Re: Project Plan No. 90001A – Air Rights Hotel
Proposed Height

SUBJECT: Air Rights Hotel Project
#9-00001A

AIR RIGHTS HOTEL

FIGURE 3.2

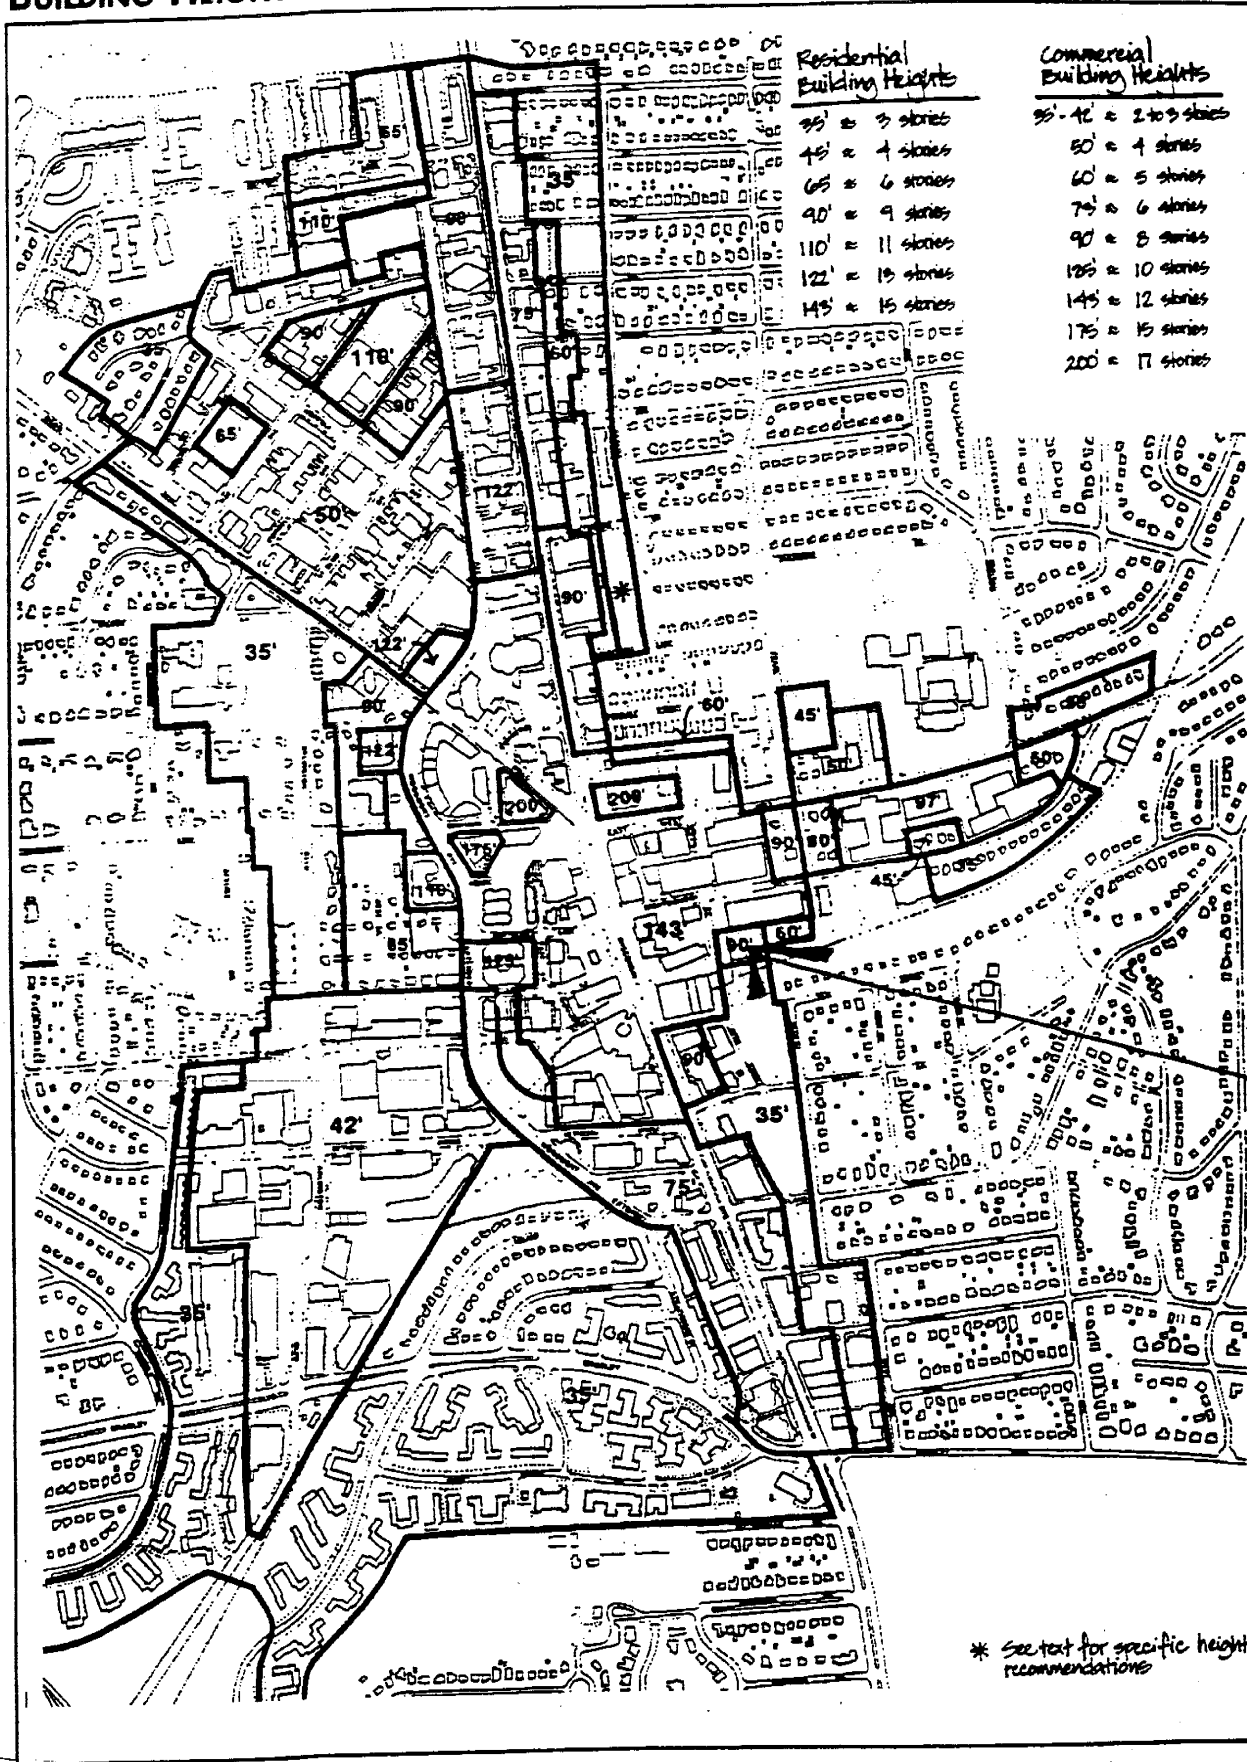
Reduce the height of the hotel to 90 feet as recommended in the 1994 Sector Plan for the Bethesda Central Business District.

The proposed hotel is 20 feet over the height recommended by the 1994 Sector Plan for the Bethesda Central Business District. The site is located at the edge of the Metro Core District, between older existing buildings of 149 feet (Air Rights office building on Wisconsin Avenue to the west) and 124 feet (Marriott Courtyard Hotel to the northwest) and Elm Street Park. Although the site is zoned CBD-2, the specific maximum height of 90 feet is recommended for this site on page 39 of the Sector Plan. Stepping down in height from the core of the CBD to the surrounding single-family residential communities is a basic tenet of the 1994 Plan.

Community-Based Planning recommends approval of the Air Rights Hotel project plan with a reduction in the proposed height from 116.5 feet to 90 feet.
